Regulation No. 125 (Forward field of vision of drivers)

Proposal for amendments to Regulation No. 125 (Forward field of vision of drivers)

Submitted by the expert from Japan*

Figure 1

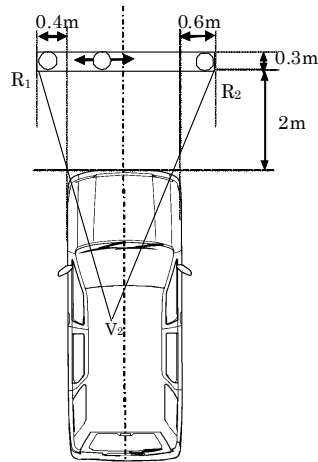
Insert a new paragraph 5.1.4., including new figures 1 and 2, to read:

"5.1.4. A 1.2 m tall cylindrical object with a diameter of 0.3 m that is situated inside the space bounded by a vertical plane located 2.0 m in front of the vehicle, a vertical plane located 2.3 m in front of the vehicle, a vertical plane located 0.4 m from the driver's side of the vehicle, and a vertical plane located 0.6 m from the opposite side of the vehicle shall be at least partially visible when viewed directly from V2 (see figure 1), regardless of where the object is within that space, unless it is invisible due to a blind spot(s) created by the A pillars, windscreen wipers, or steering wheel.

Figure 2

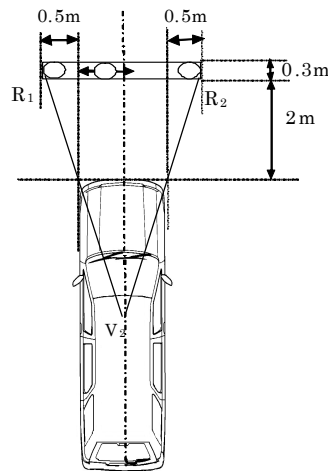
If the driver's seat is located in the central driving position of the vehicle, the 1.2 m-tall cylindrical object shall be situated inside the space bounded by a vertical plane located 2.0 m in front of the vehicle, a vertical plane located 2.3 m in front of the vehicle, a vertical plane located 0.5 m from the side of the vehicle (see figure 2).
